**RE: Variation No. 1 Clare County Council Development Plan 2023-2029, Vol.3a(iv)  
 adoption of Ennis Local Transport Plan - Connecting Tulla Road to Gort Road Ennis.**

I, the below signed, am objecting to the proposal to connect the Tulla Road to the Gort road via the Corrovorrin Graveyard pathway in the Corrovorrin Estate.

Extract from Clare Development Plan map 2023-2024 showing Corrovorrin area as Flood Zones A & B along with open space zoning of field behind Corrovorrin Drive

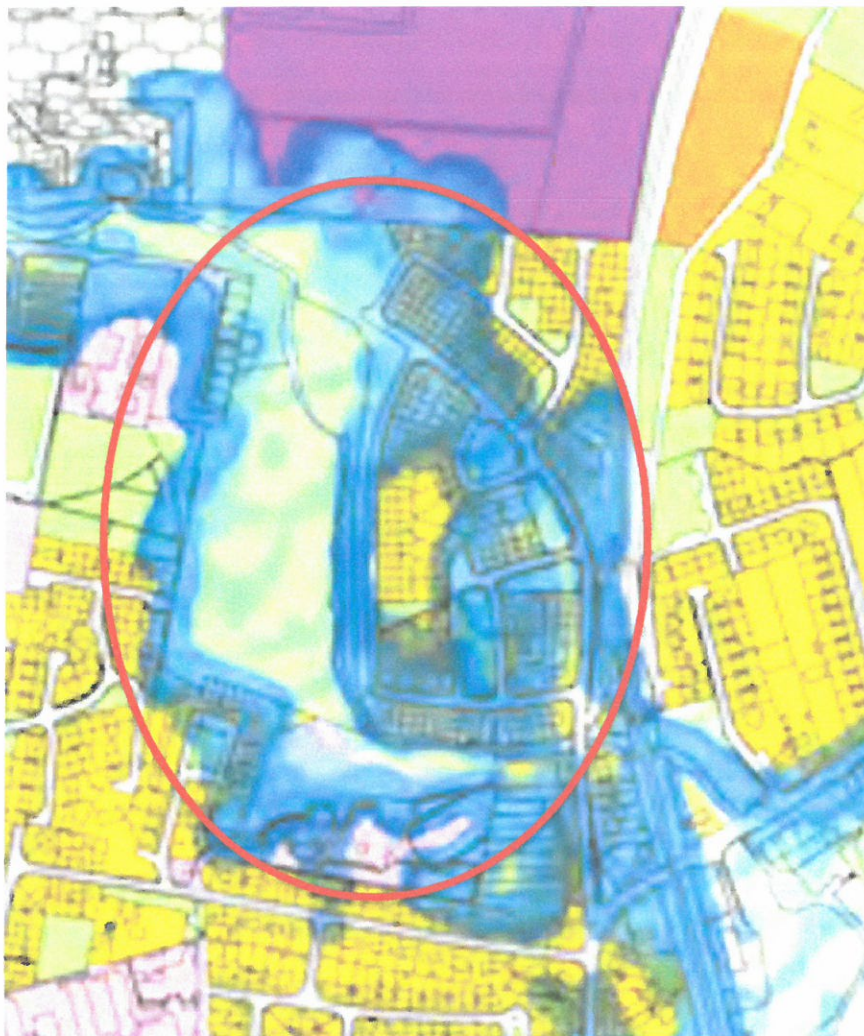
## **Flood/Riparian zone**

The field running from the Corrovorrin graveyard along the back of Corrovorrin Drive is within Flood Zone A and is a Riparian zone. Zoned as open space it is home to wide variety of wildlife including protected species such as Otters and Kingfishers (which are Amber-listed (Birds of Conservation Concern in Ireland)). There are also regular sightings of bats in both the graveyard and the field. Any kind of development in this field will cause significant disruption to the feeding and breeding grounds of these and many other species of wildlife who have flourished in this undisturbed environment over the last few years.

This land is an essential part of the conservation of the wildlife of the River Fergus and as such is entirely unsuitable for development.
